TECHNICAL SERVICE BULLETIN 10043

MODEL(S): 150GTL, 200GTL

DESCRIPTION: Receiver overloads when receiving a strong signal, resulting in distorted audio. In addition there may be a warble in the modulation when transmitting (which the customer might describe as a popping sound during transmit).

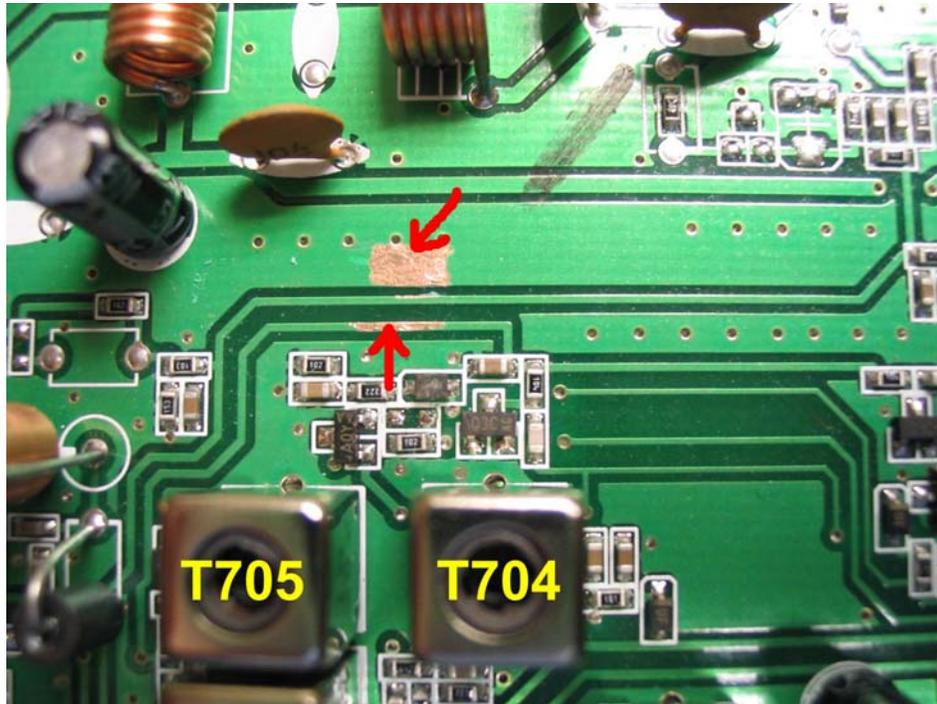
ACTION: RF is bleeding into the receiver front-end. Apply the following fix:

For both the 150GTL and 200GTL, install a 1 μ F electrolytic capacitor across C607. (From C607 to ground)

150GTL

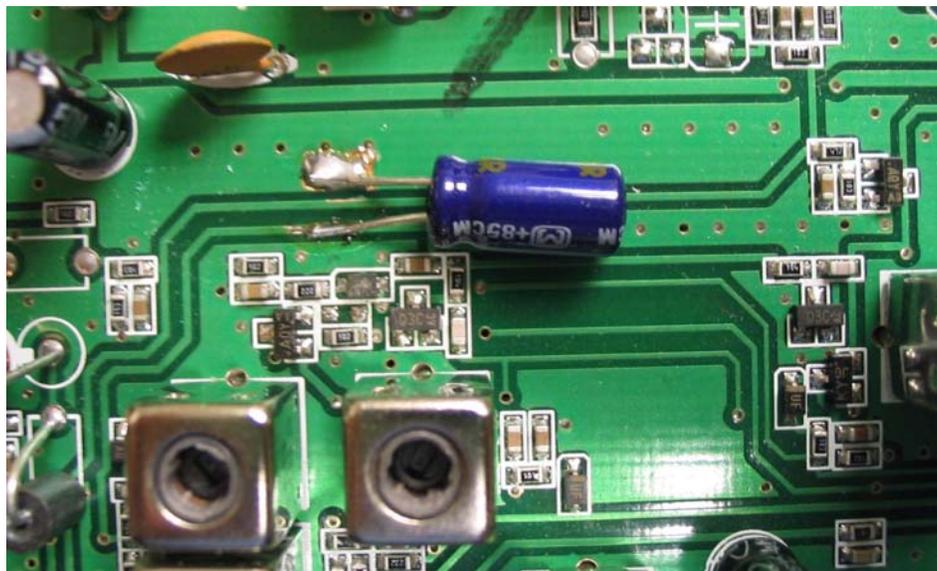
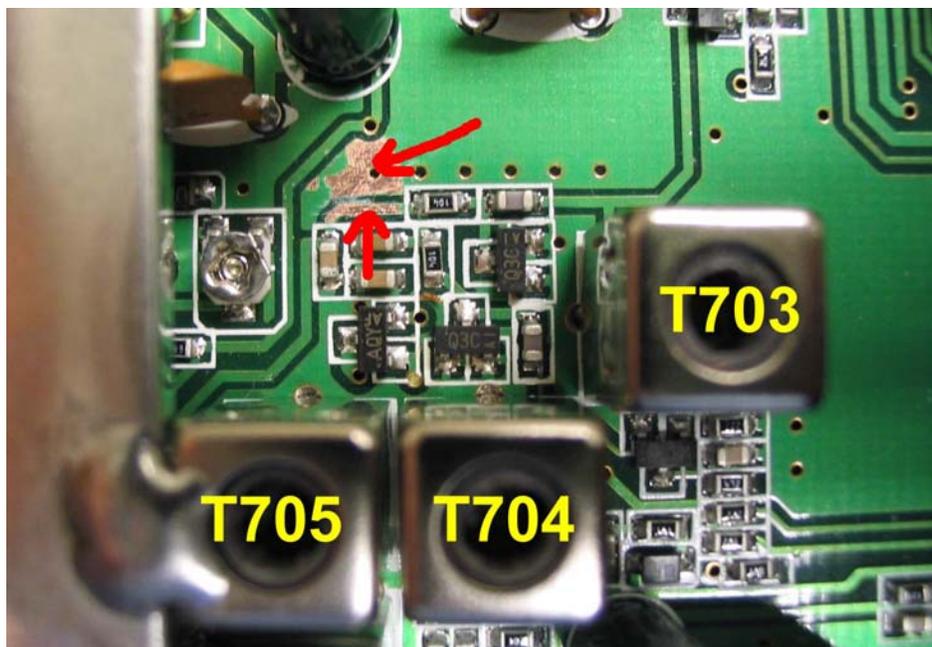
Scrape to expose the circuit traces as indicated above. The large copper area is ground.

Solder the capacitor as shown. Be sure to observe polarity. Put some glue under the capacitor so that it cannot move.

200GTL

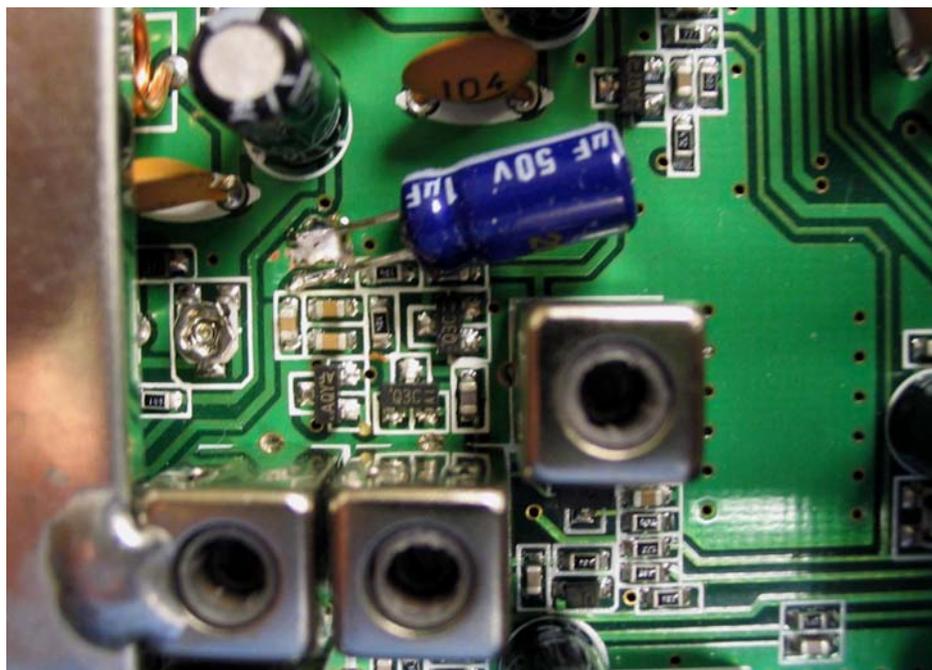
Scrape to expose the circuit traces as indicated above. The large copper area is ground.

Solder the capacitor as shown. Be sure to observe polarity.
Put some glue under the capacitor so that it cannot move.
